Comment Set B0002, cont.
Boulevard Planning Group

Responses to Comment Set B0002

Boulevard Planning Group

Fig. 21 Location of springs (S) in the Tierra del Sol watershed, with east-west trending major dike shown in red.

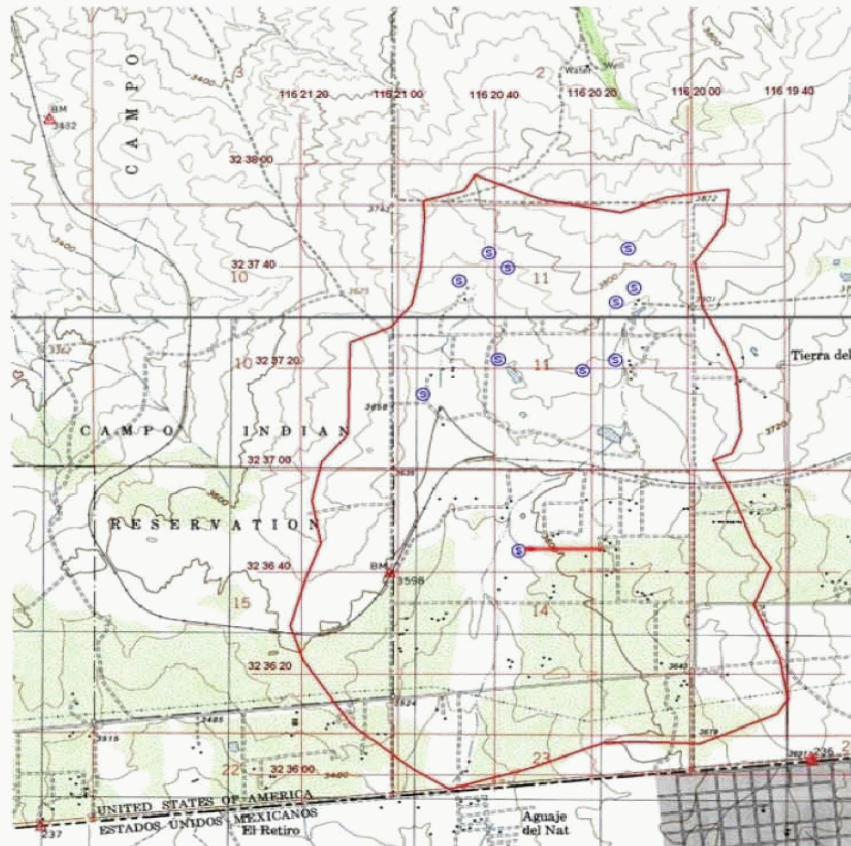
In Fig. 20, note that the southernmost spring is located precisely at the western extremity of the 1,465-ft dike shown in Fig. 10. This spring sustains a rather large isolated specimen of coast live oak (*Quercus agrifolia*), shown in Fig. 22. This tree appears in Fig. 19, at the western edge of the dike (compare Figs. 19 and 20). Although drought tolerant, a coast live oak requires some moisture for its normal development. Thus, the presence of an oak specimen near a spring in the Tierra del Sol watershed is further evidence of a hydraulic connection between surface water and groundwater.
